BOARD OF COMMISSIONERS OF THE PORT OF NEW ORLEANS
NOTE TO PERSPECTIVE BIDDERS
CONTRACT FOR
FRANCE ROAD TERMINAL AND JOURDAN ROAD
REPAIRS TO PUMP STATIONS P2-P5 AND
PATTERSON PUMP STATION
DAMAGE BY HURRICANES KATRINA AND GUSTAV

August 1, 2011

ADDENDUM NO. 3

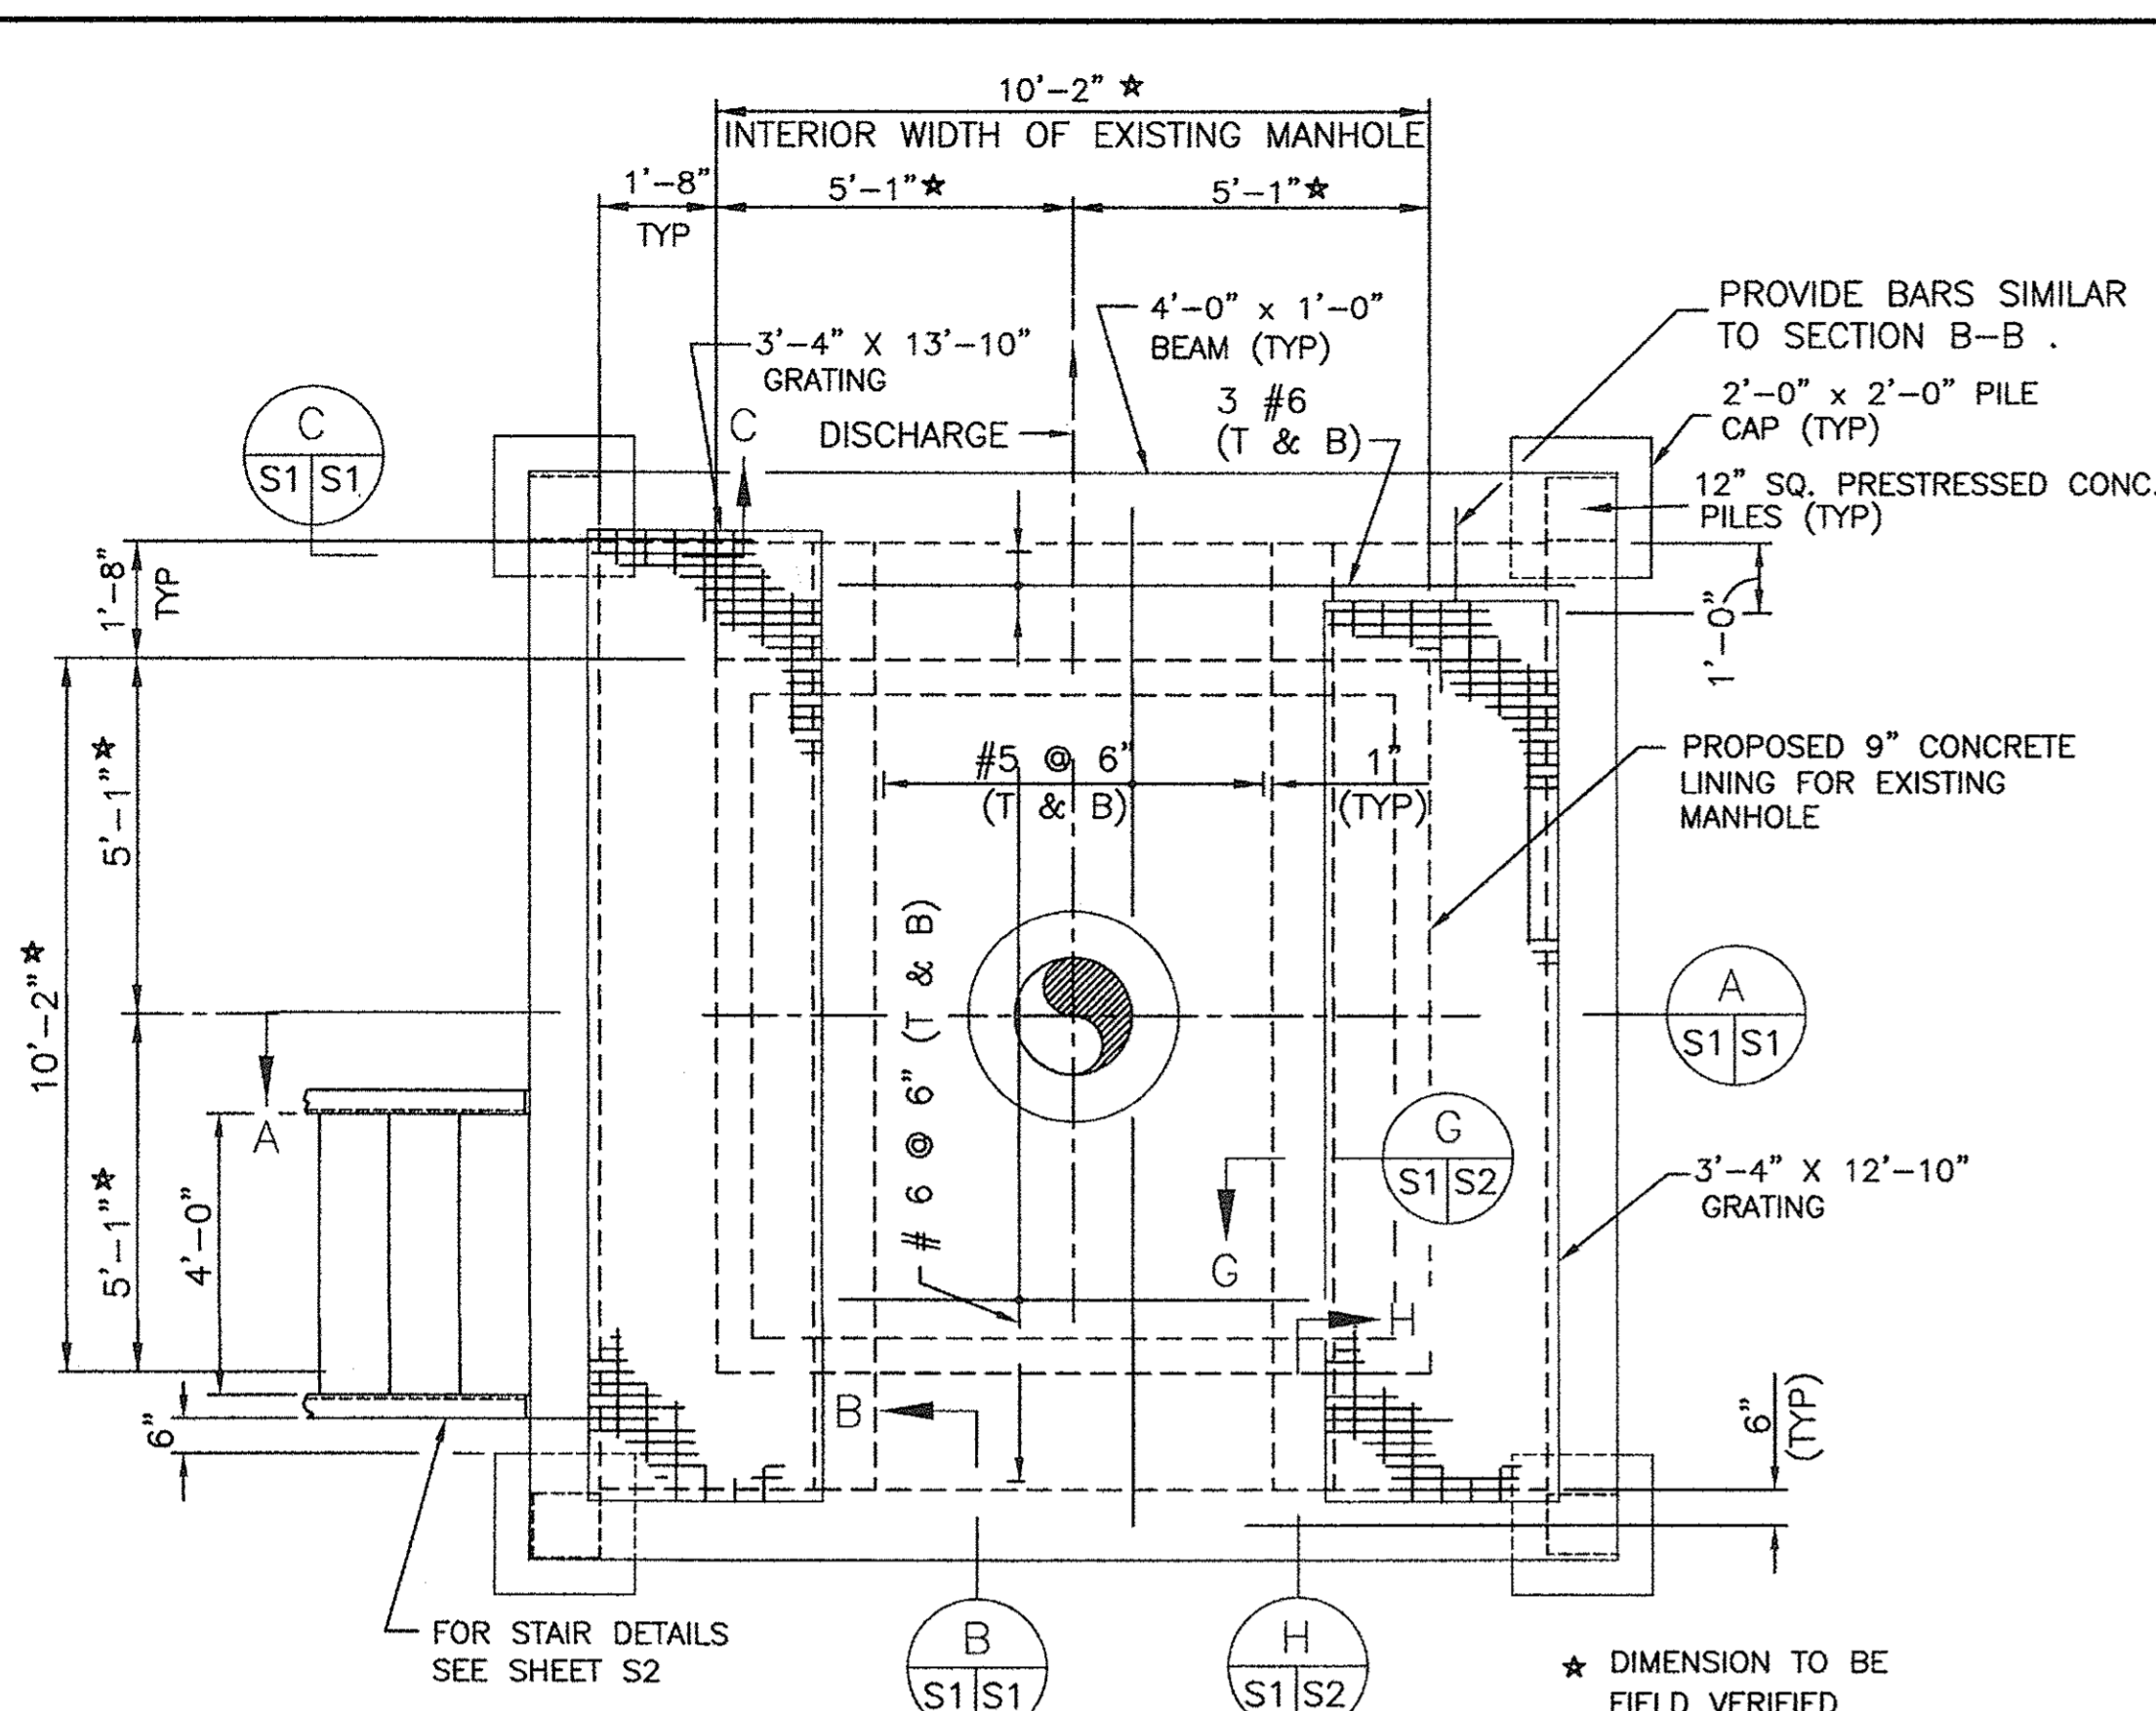
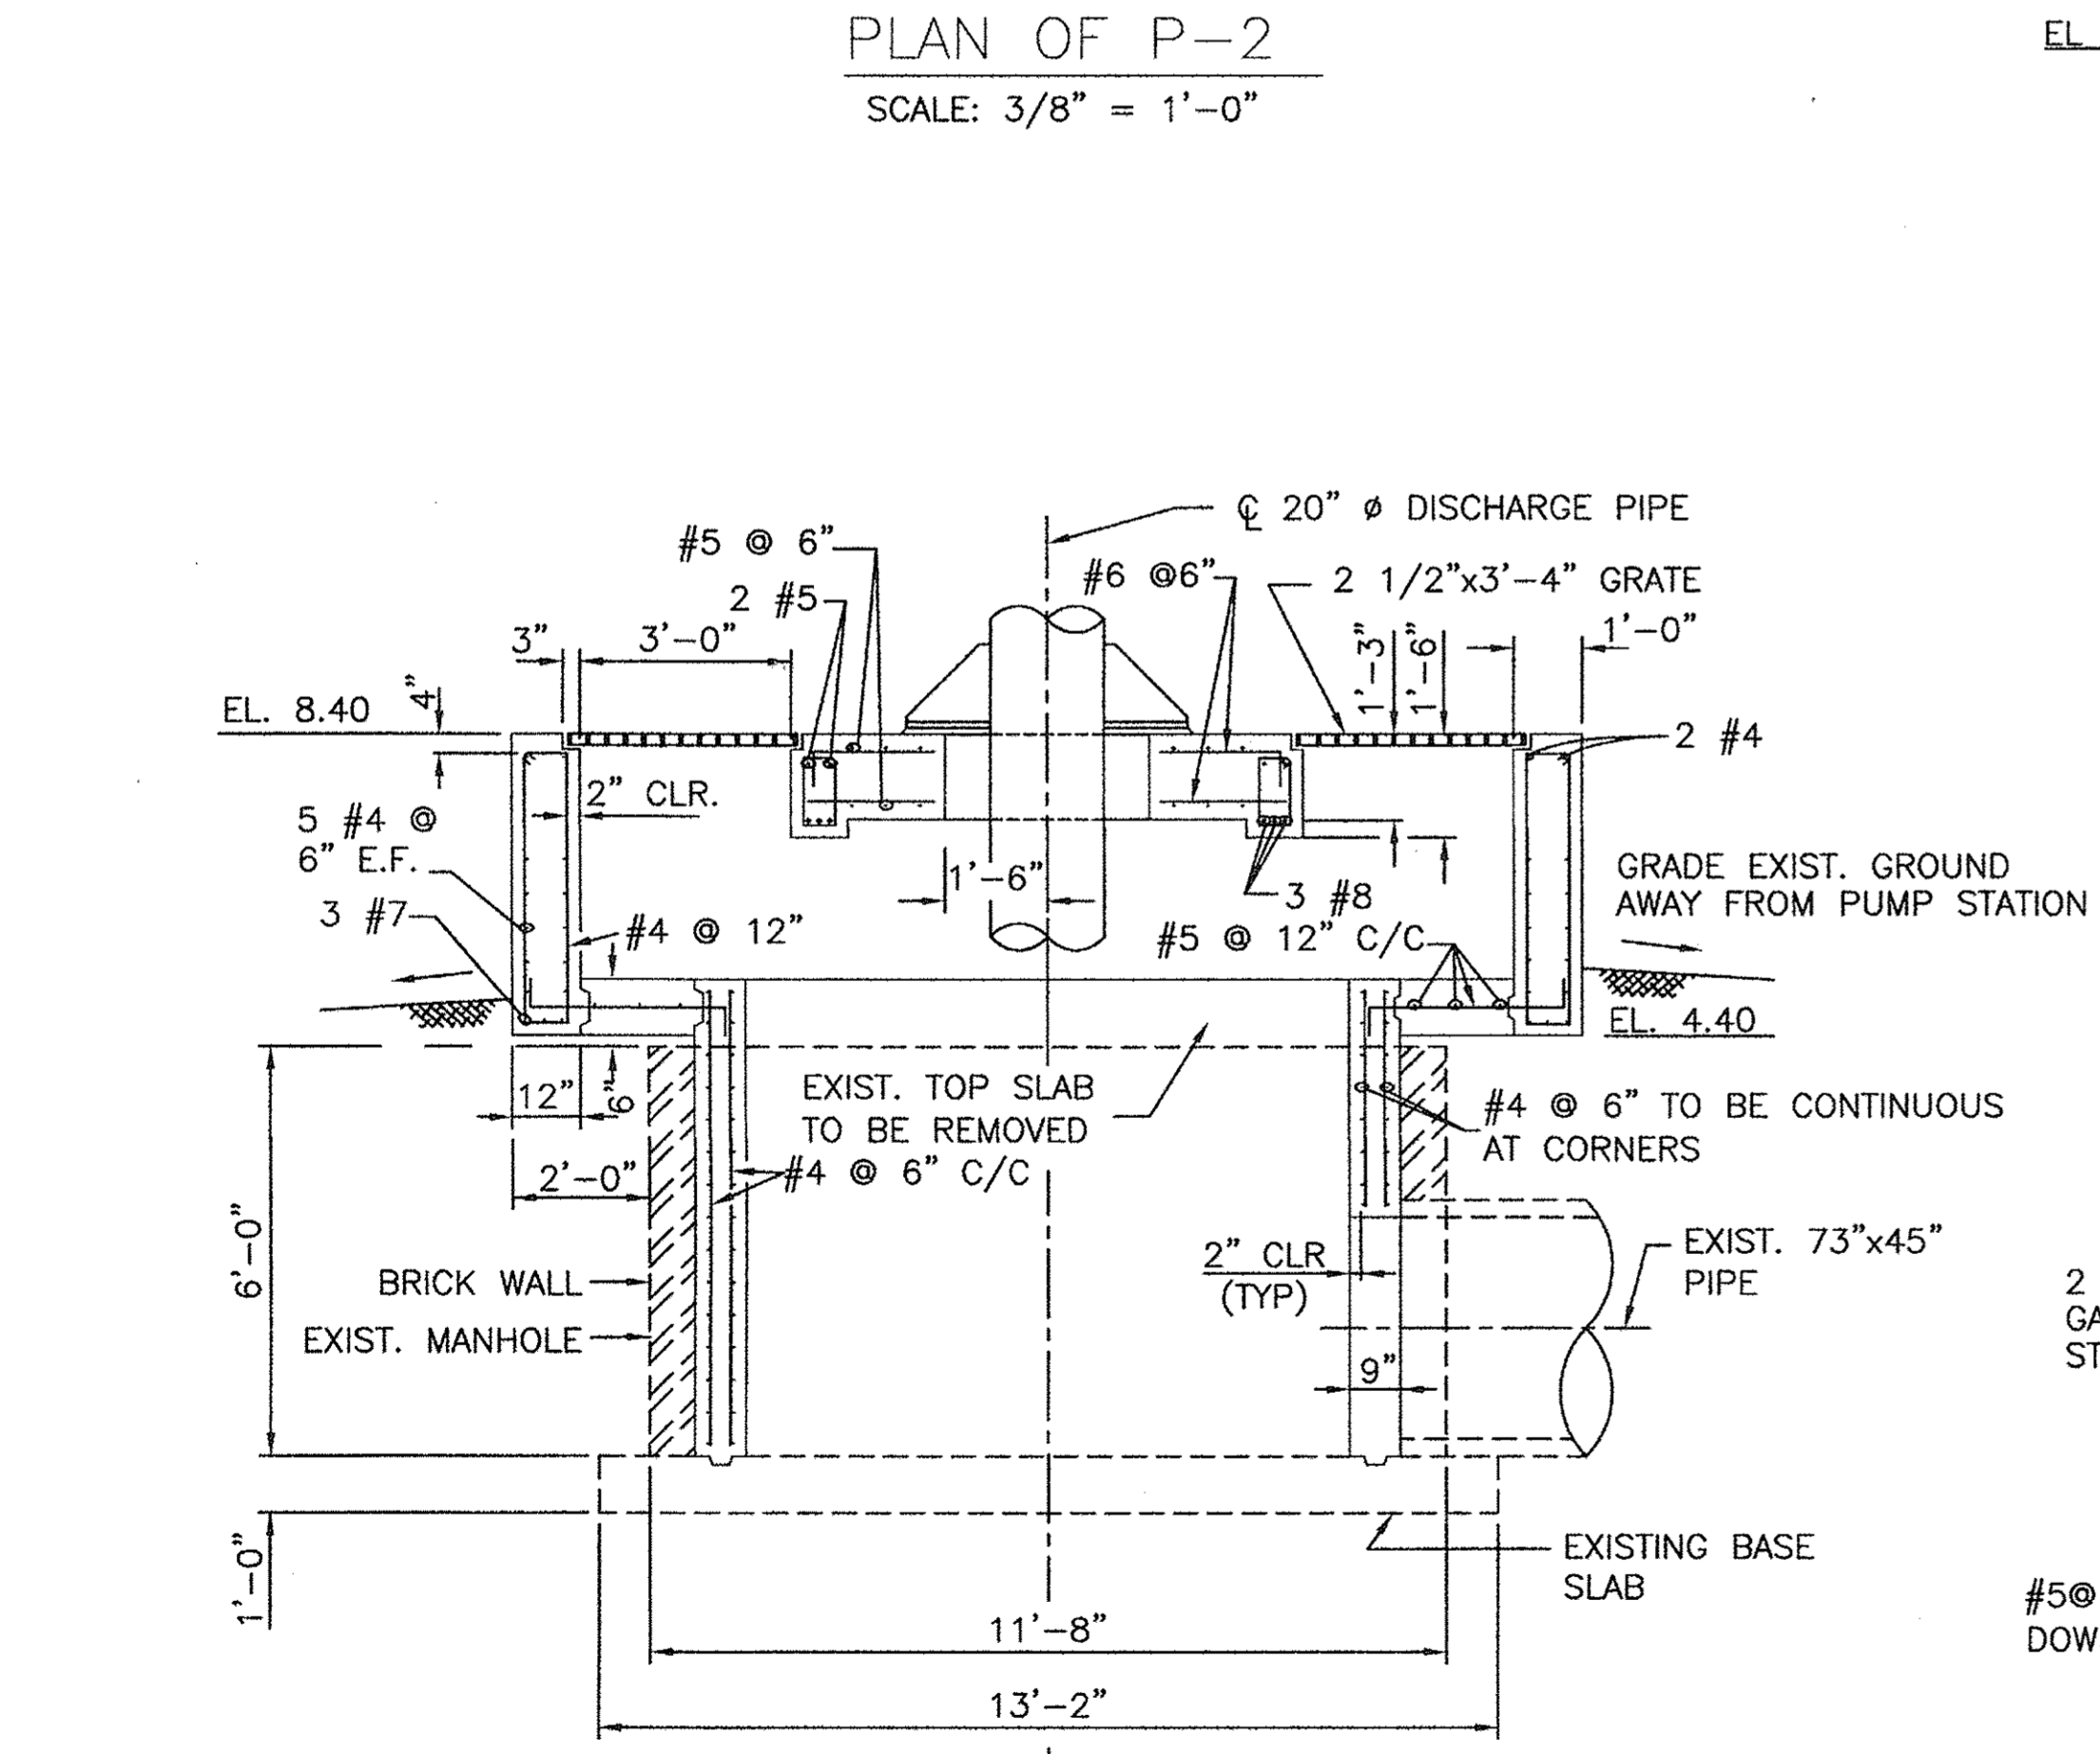
Q9: The existing pumps must be removed from their present location and re-installed with new anchors through the base plate. Grouting of the base plates is required. Please provide drawings of the existing concrete structure, including the size of the pump penetration, so that we may determine the area of the grout and the space available for drilling new anchors as shown on the project drawings.

Drawing M11-7038-S1 is being issued with this Addendum No. 3 for information only. This drawing shows the layout of the wet well and pump housing attachment.

Answer: We are including a drawing showing the existing concrete structures as part of this Addendum. See Item 24 below.
